Office Action Summary	Application No.	Applicant(s)
	10/717,788	REITER, WILLIAM P.
	Examiner Jon A Szumny	Art Unit 3632

This is the first office action for application number 10/717,788, Waste Container Stabilizer, filed on November 20, 2003.

Figure 2

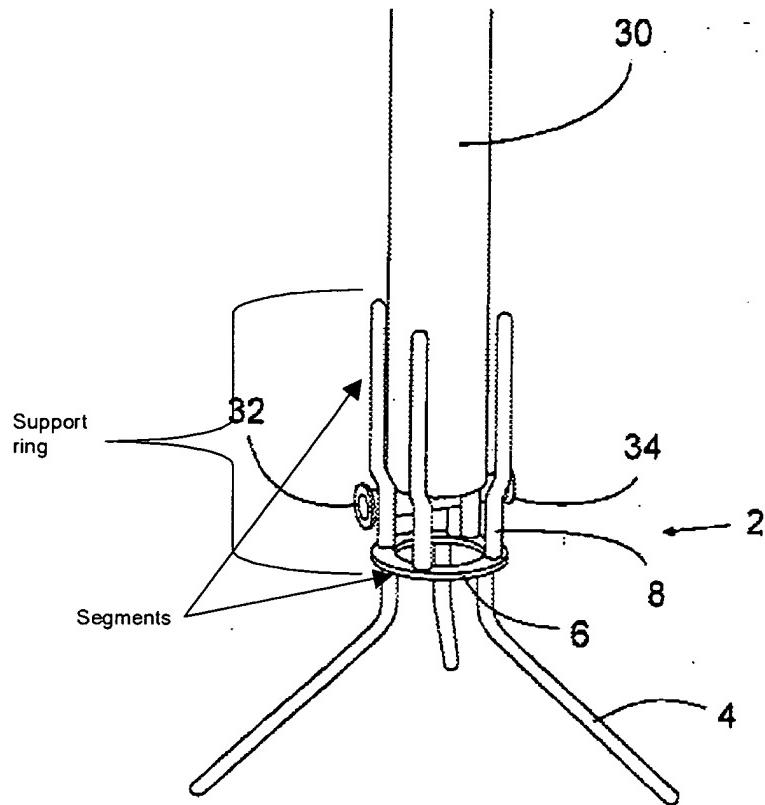
Nauseda et al. '901 discloses a stabilizer (above) comprising a support ring (above), and a plurality of legs (4), wherein each of the legs comprises a top surface (above) comprising an arcuate shape complementary to the support ring (see paragraph 44, the bottom of the support ring has a female threaded connection and the tops of each of the legs have a male threaded connection, so both of these connections are complementary arcuate surfaces), wherein rotation of each leg relative to the support is prevented when the leg is attached to the support ring (for instance, when the leg is rotated more after the threads are already fully engaged, or when the legs are rotated about an axis different than that of the threaded connections), wherein the

support ring comprises a segmented support ring comprising a plurality of segments (above), wherein a container (30) is sized to fit within the support ring when the stabilizer assembly and the waste container are supported on a surface.

However, Nauseda et al. '901 fails to specifically teach at least two of the legs to each comprise a hollow ballast compartment with an opening filled with a ballast selected from sand, gravel, water, metal shot, concrete and combinations of two or more thereof, and fails to specifically teach the opening into the compartment to be covered by the support ring when the legs are attached to the support ring.

Nevertheless, Farmer '085 teaches the concept of filling a hollow ballast compartment in a leg of a stabilizer with ballast (column 3, lines 30-31), and Jones '659 teaches the concept of filling a leg (2) with ballast such as sand or gravel (column 3, line 11) via an opening (4) on the top of the leg, such that when the leg is attached to a support ring (3, the opening is covered. It would have been obvious to one of ordinary skill in the art at the time the invention was made to have modified at least two of the legs of the stabilizer of Nauseda et al. '901 so as to each have a hollow ballast compartment filled with a ballast as in Farmer '085 so as to provide for a more stable stabilizer. Further, it would have been obvious to have constructed an opening into the ballast compartment on the top of each leg such that each compartment is covered by the support ring when the legs are attached to the support ring so as to provide for a more aesthetically pleasing stabilizer by concealing the openings. Finally, it would have been obvious to have used sand or gravel as the ballast as in Jones '659 since such are well known materials in the art for use as ballast materials.
